Town of Smiths Falls
Public Works Operation Center
11 Air Care Drive
Smiths Falls ON, K7A 0B2

Date: July 29, 2026

PART 1 - General

- .1 This Addendum is issued prior to tender closing to provide revisions to the Contract Documents.
- .2 Such revisions shall become part of the Contract Documents and shall change the original contract documents only in the manner and extent stated.
- .3 Bidders shall take this Addendum into Consideration when preparing and submitting a Bid and shall acknowledge receipt of this Addendum in their bids.

1 REPAIR BAY - ELEVATION
A451 1 : 50

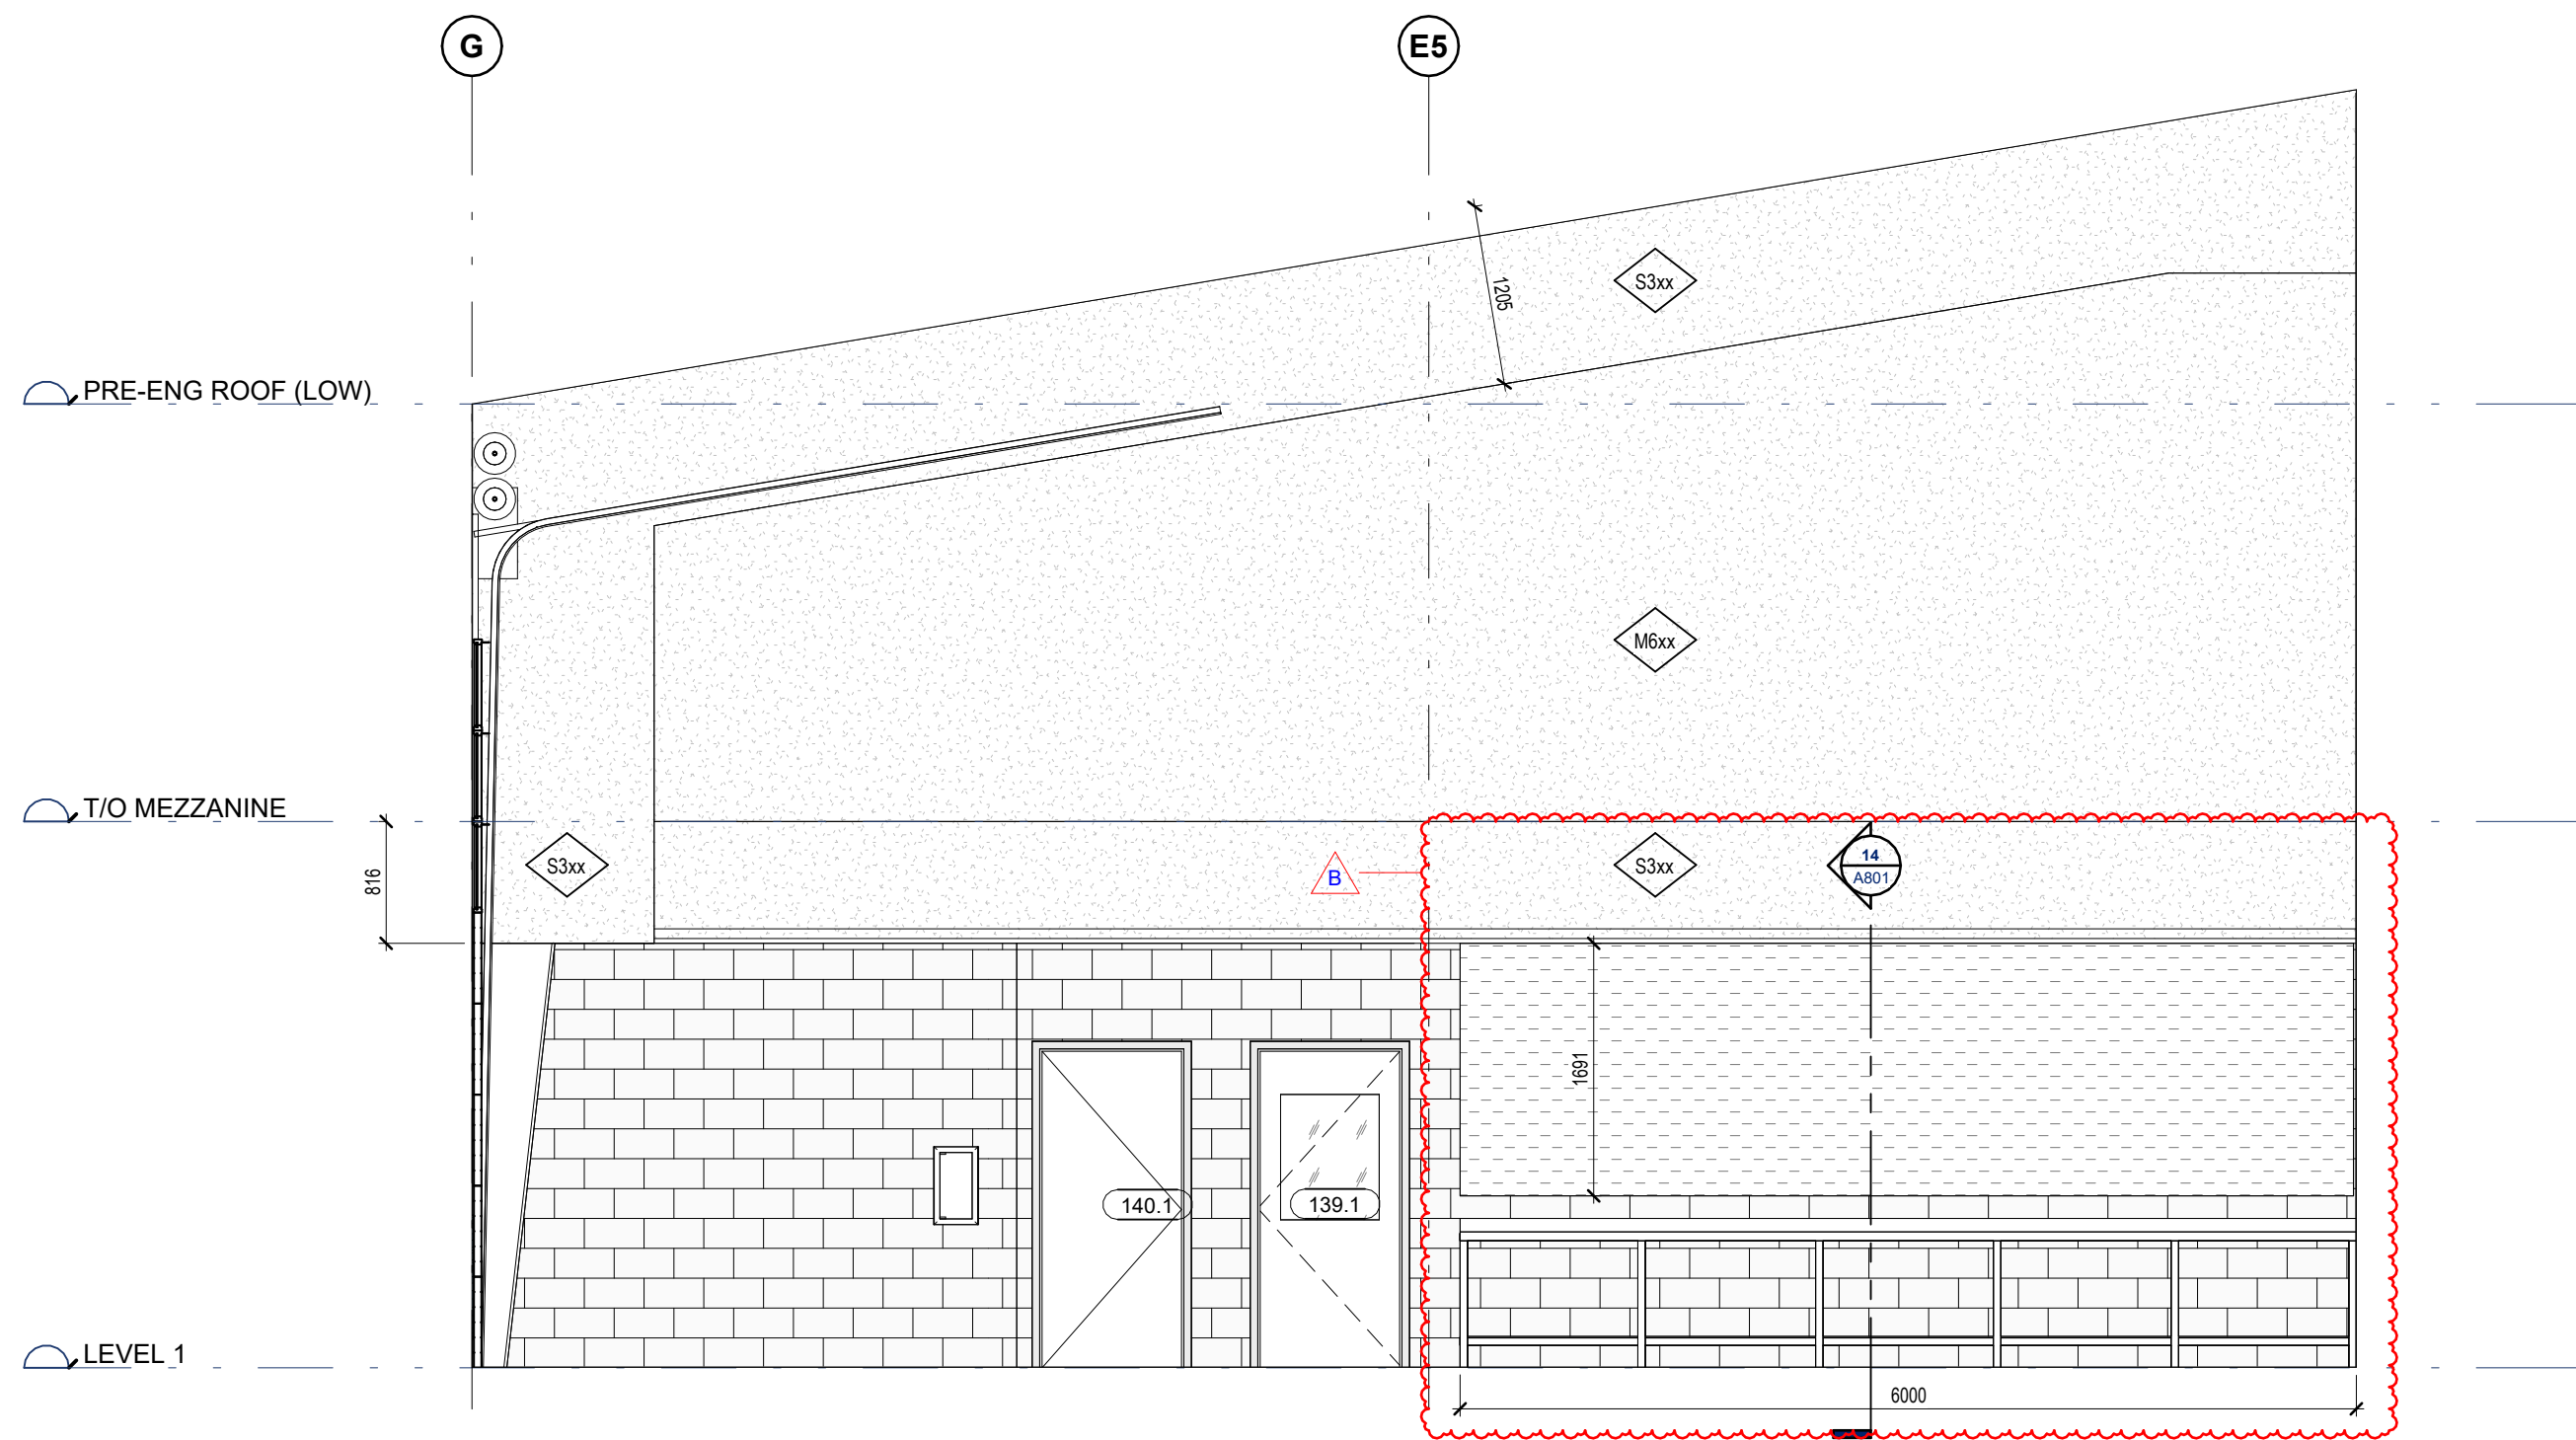
- .11 Refer to the attached Drawing A451 – INTERIOR ELEVATIONS – MAIN BUILDING:
 - .1 ADD dimensions and references to Section Detail 14/A801 for wall-mounted pegboard tool-storage panels at the Repair Bay, Wash Bay, and Service Garage elevations.

1 LONG SECTION BTW GRID B&C
A501 1 : 100

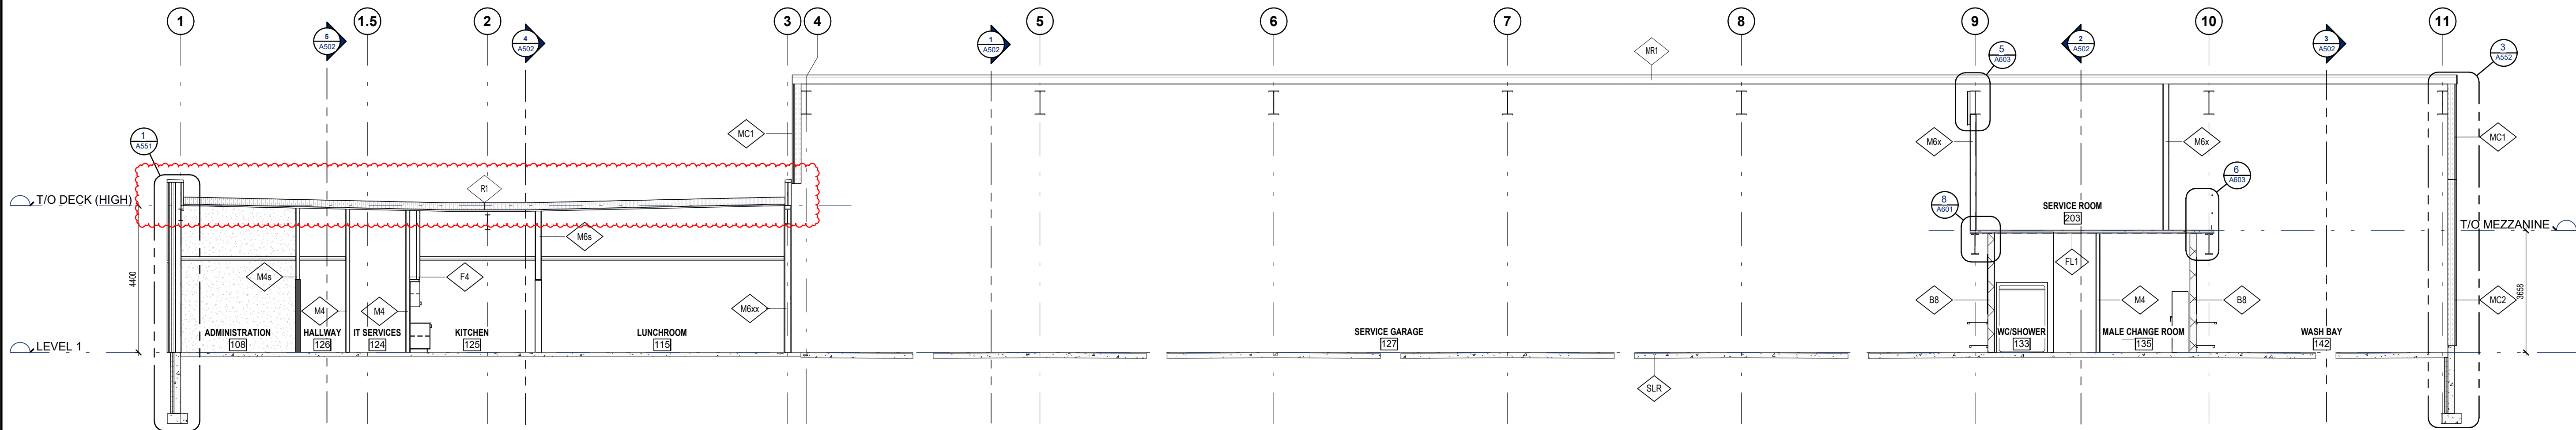
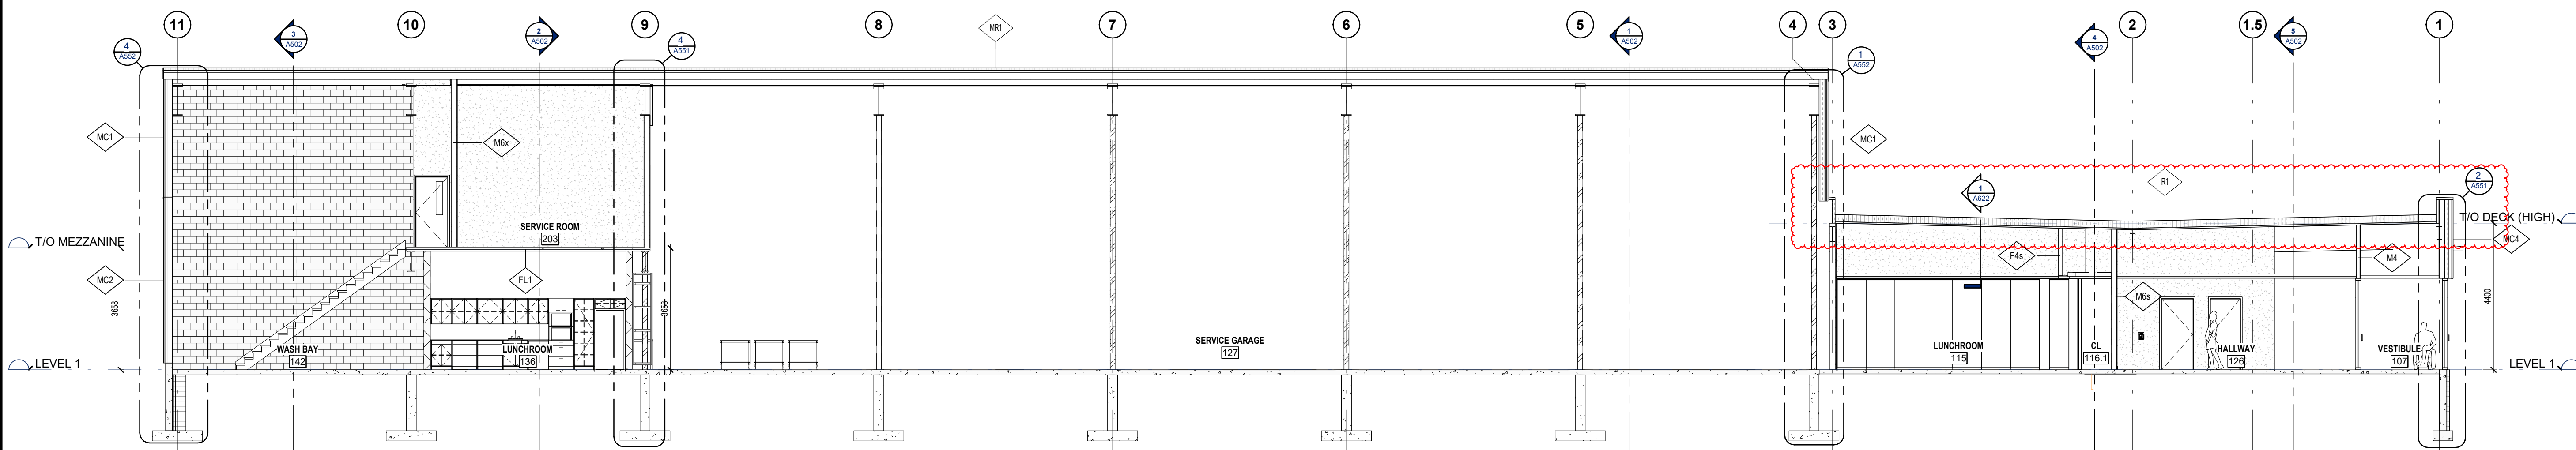
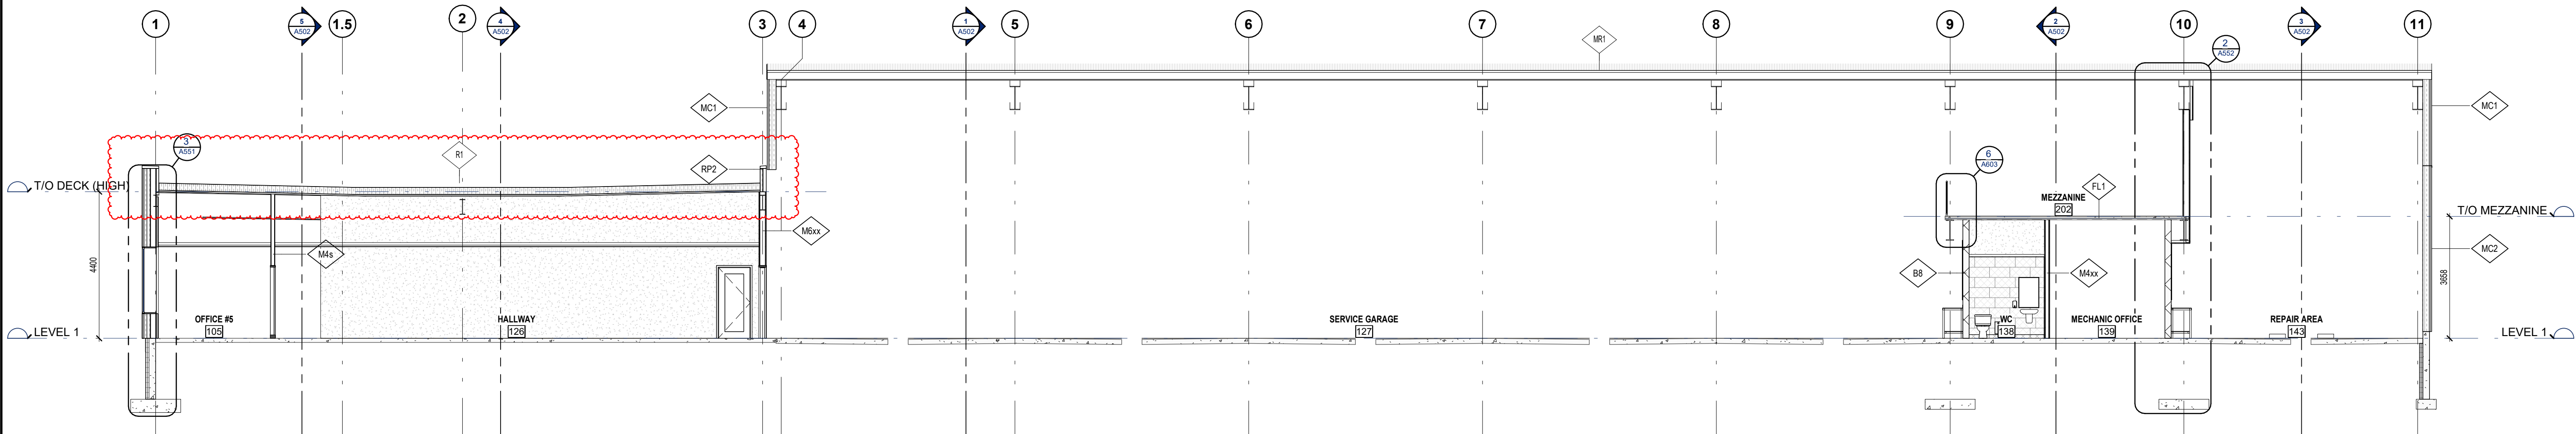
- .12 Refer to the attached Drawing A501 – BUILDING SECTIONS – MAIN BUILDING:
 - .1 REVISE Roof assemblies at Sections 1, 2, and 3/A501, including the roof type designation at Section 2/A501.

1
A602
TYP. PRE-ENG TO ROOF EXPANSION DETAIL
1 : 5

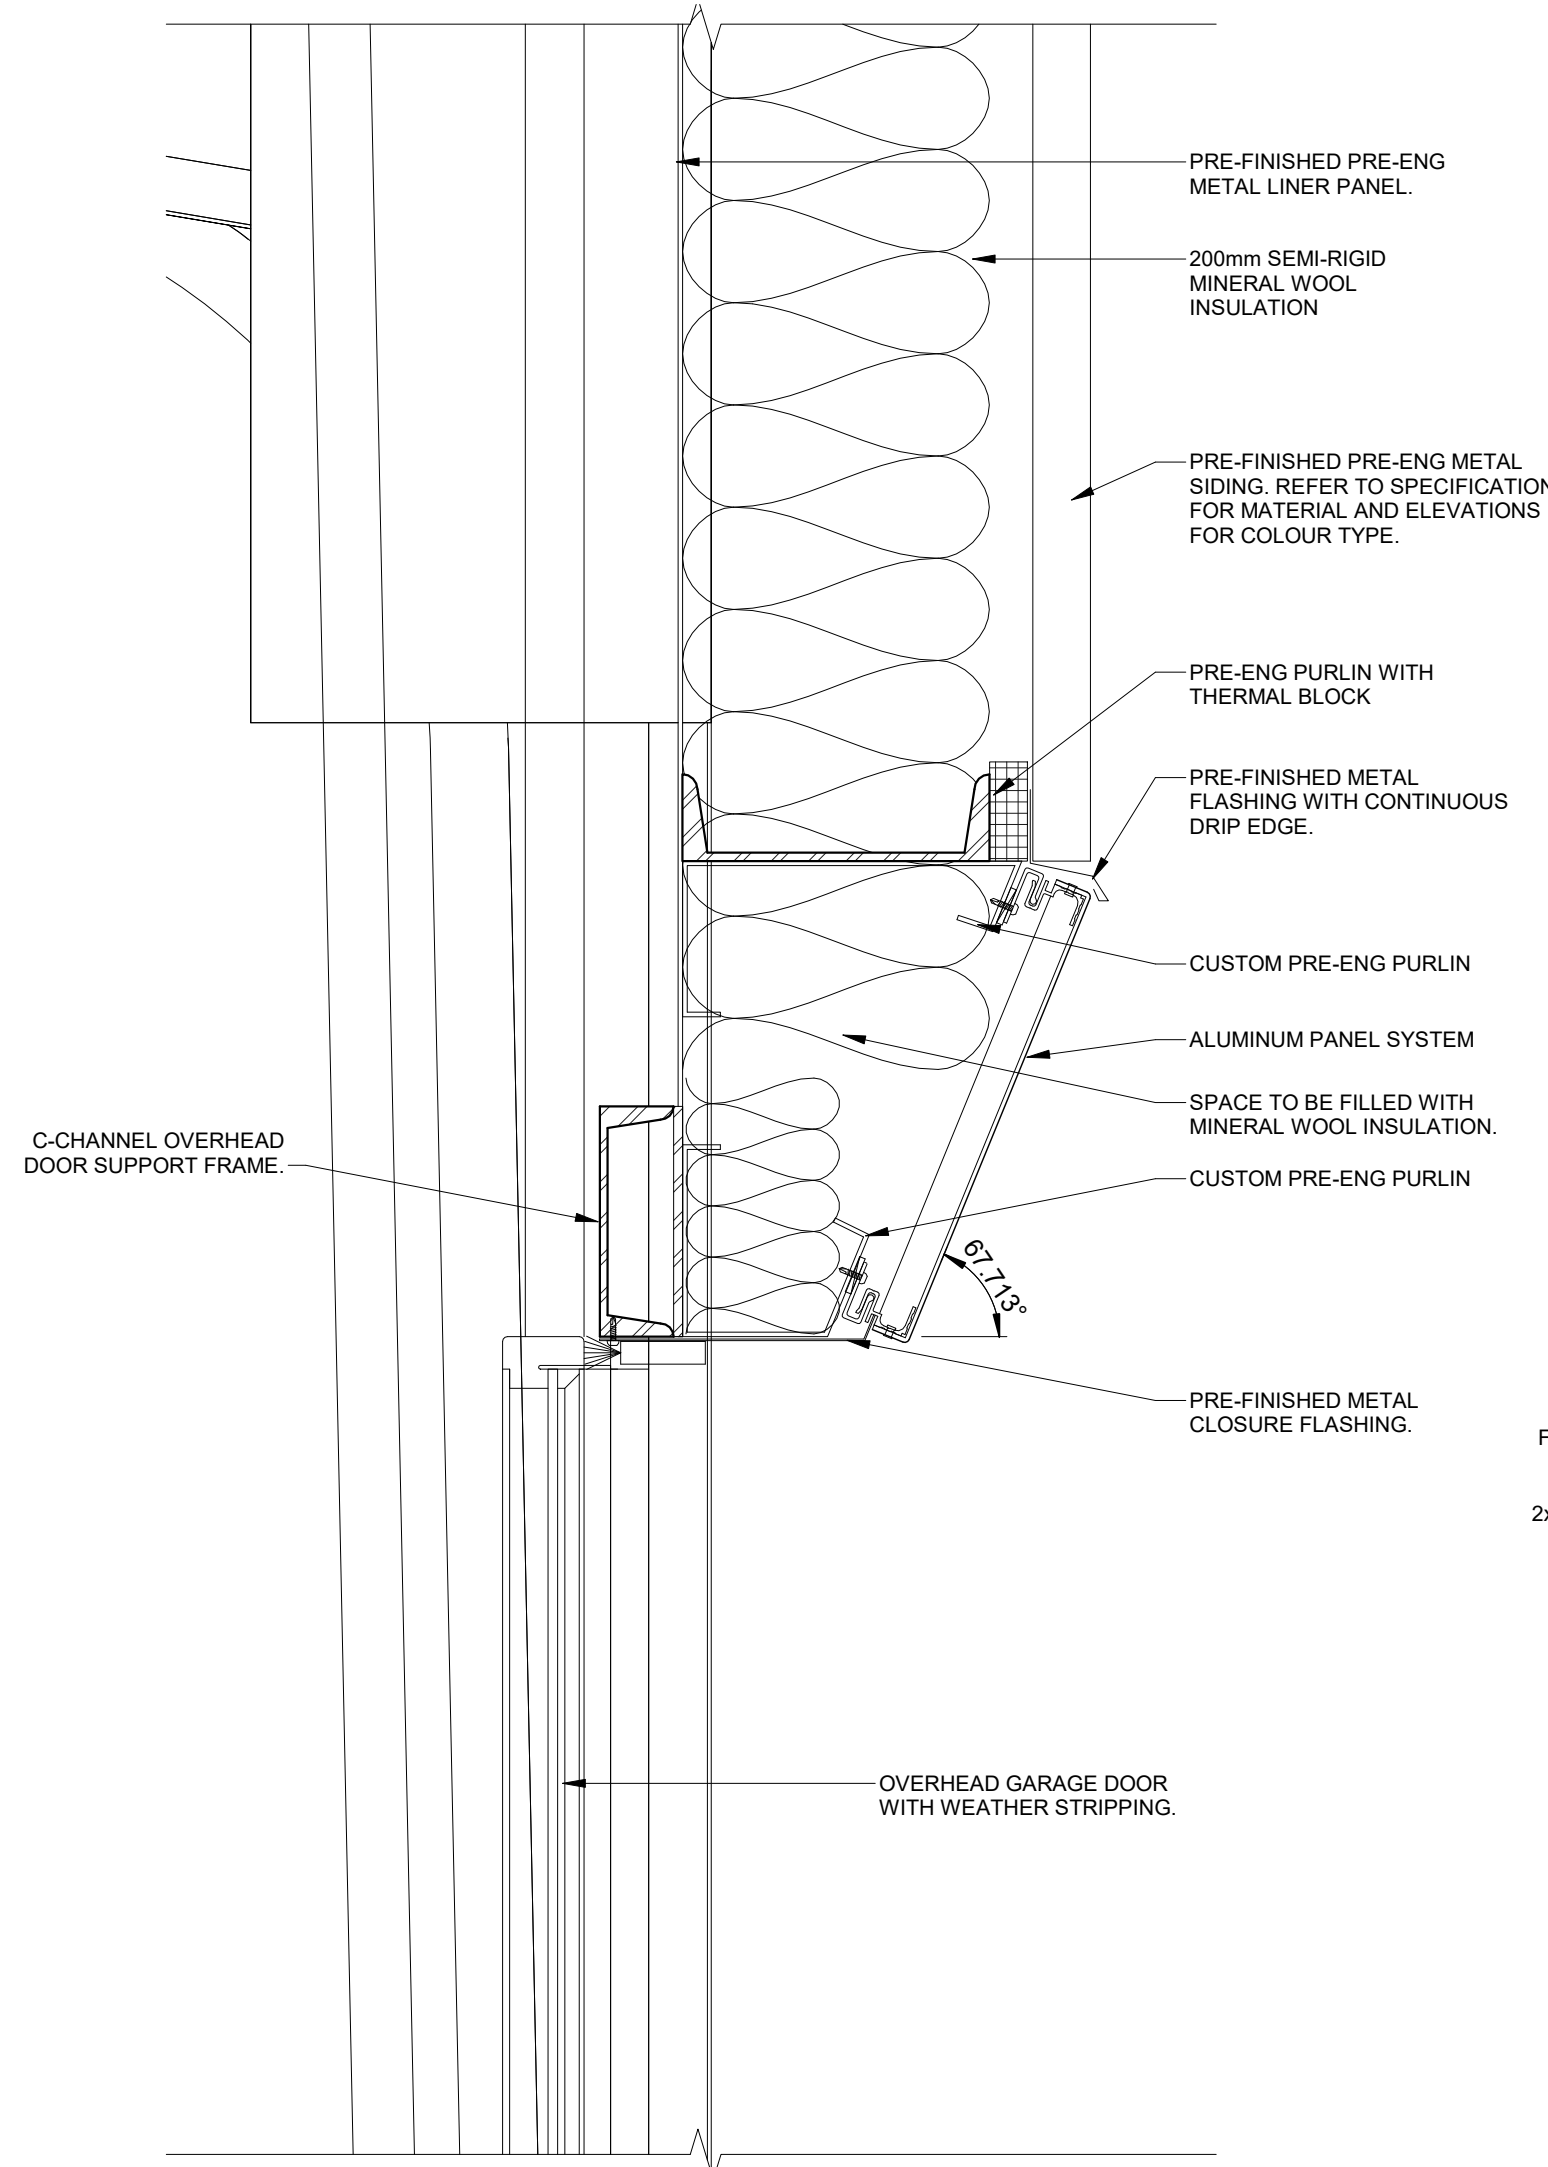
- .14 Refer to the attached Drawing A602 – SECTION DETAILS:
 - .1 REVISE Exterior sheathing and insulation materials and ADD dimensions at Detail 1/A602 – Typical Pre-Engineered Building-to-Roof Expansion Detail.
